ADDENDUM

NO. 1

PROJECT NAME: New Operations Building

PROJECT NUMBER: 1971-05-01

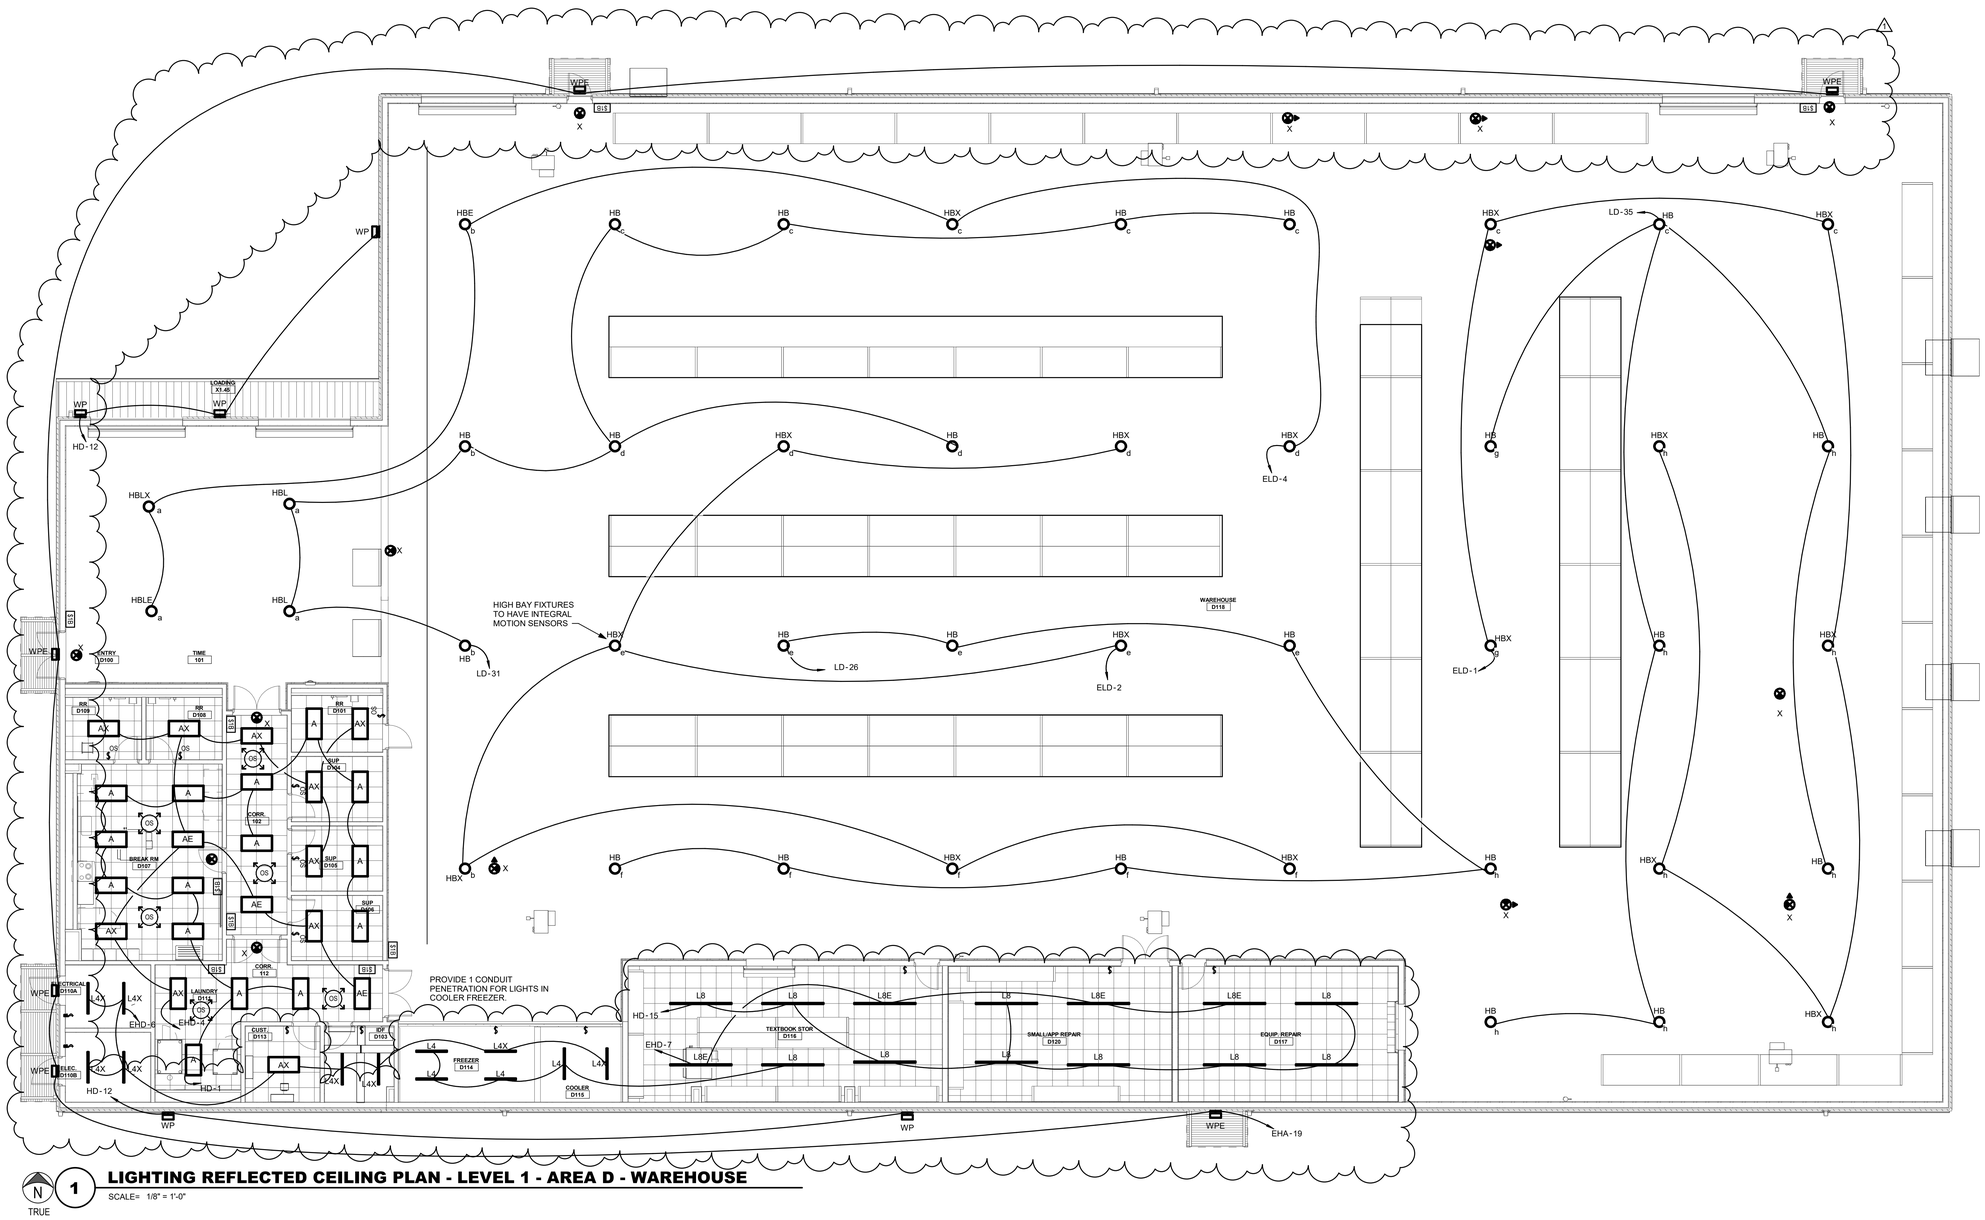
AD No 1, Elec. Item 15: To the Drawings, Sheet E2.04, "LIGHTING REFLECTED CEILING PLAN – LEVEL 1 – AREA D - WAREHOUSE,"

Job No: 1971-05-01	Sheet No: E2.05
Drawn By: HB/BRH	
Date: 09/18/2025

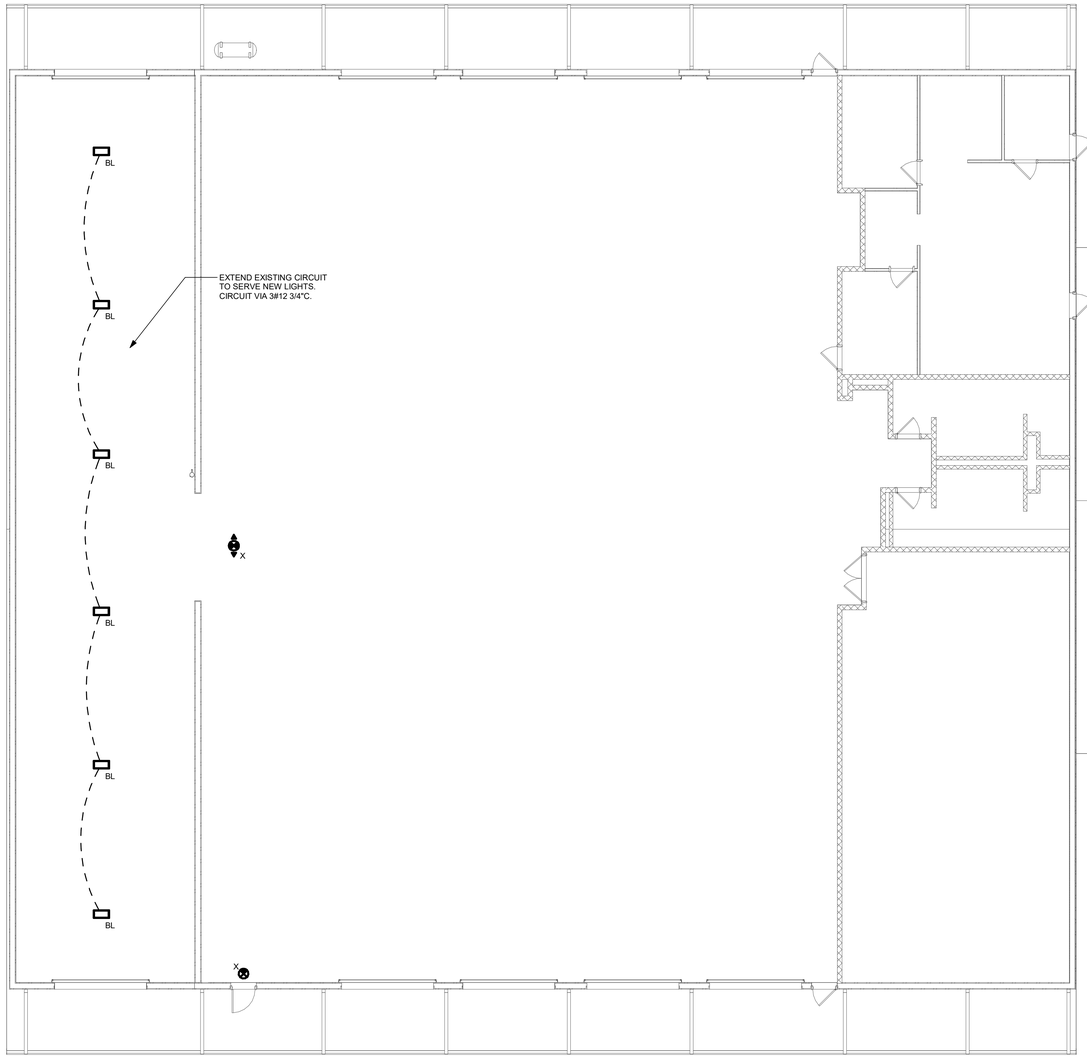
AD No 1, Elec. Item 16: To the Drawings, Sheet E2.05, "LIGHTING REFLECTED CEILING PLAN - BUS WASH, MECHANIC BAY & STORAGE"
